UNITED STATES DEPARTMENT OF COMMERCE United States Patent and Trademark Office Address: COMMISSIONER FOR PATENTS P.O. Box 1450 Alexandria, Virginia 22313-1450 www.usplo.gov

| APPLICATION NO. | FILING DATE | FIRST NAMED INVENTOR | ATTORNEY DOCKET NO. | CONFIRMATION NO. |
|---------------------|-------------------------|----------------------|---------------------|------------------|
| 10/535,456 | 05/19/2005 | Marten Johansson | BGEE 2 00113 4290 | |

| Office Action Summary | | Application No. | Applicant(s) | | | | | |

DETAILED ACTION

Fig. 1 (PRIOR ART)

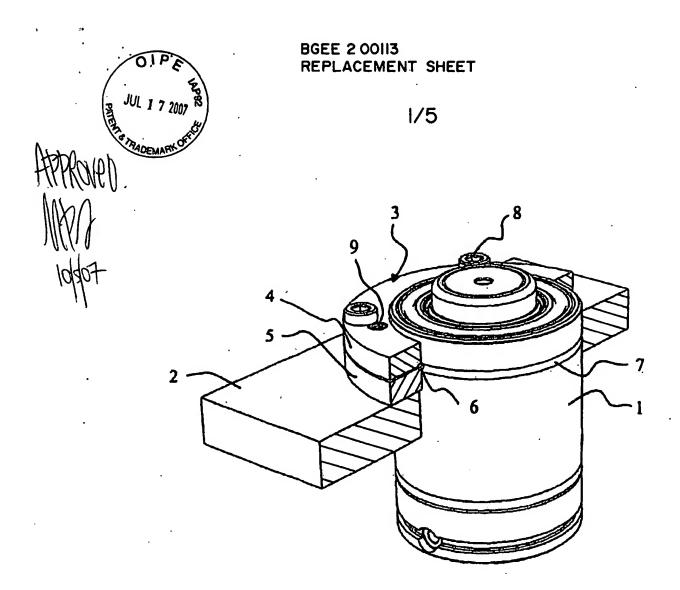
7. Claims 10 and 14-18 are rejected under 35 U.S.C. 103(a) as being unpatentable over Admitted prior art (Figure 1).in view of Manton.

As to claims 10, 14 and 15, Admitted prior art (Figure 1) discloses a method of fixing a gas-filled spring 1 in a machine tool 2, by which method an upper flange half 4 and a lower flange half 5 of a flanged connection which can be joined together are fitted at least partially around the gas-filled spring and a locking ring 6 arranged between the flange halves is at least partially fitted around the gas-filled spring in a groove 7 of complementary design and is fixed between the flange halves securing the gas-filled spring (Figure 1).

Admitted prior art fails to disclose a method wherein, when joining together the flange halves, a clamping force is applied around the gas-filled spring by a fixing

As to claim 16, Admitted prior art (Figure 1) discloses a method wherein the clamping force is generated when the flanged connection is fitted to the machine tool **2** and that the clamping force is of a predefined magnitude.

As to claim 17, Admitted prior art (Figure 1) discloses a method wherein the magnitude of the clamping force is adjusted by adjusting the tightening torque of fasteners 8 used for fitting the flanged connection to the machine tool 2.

As to claim 18, Admitted prior art (Figure 1) discloses a method wherein the clamping force serves to prevent rotation of the gas-filled spring 1.
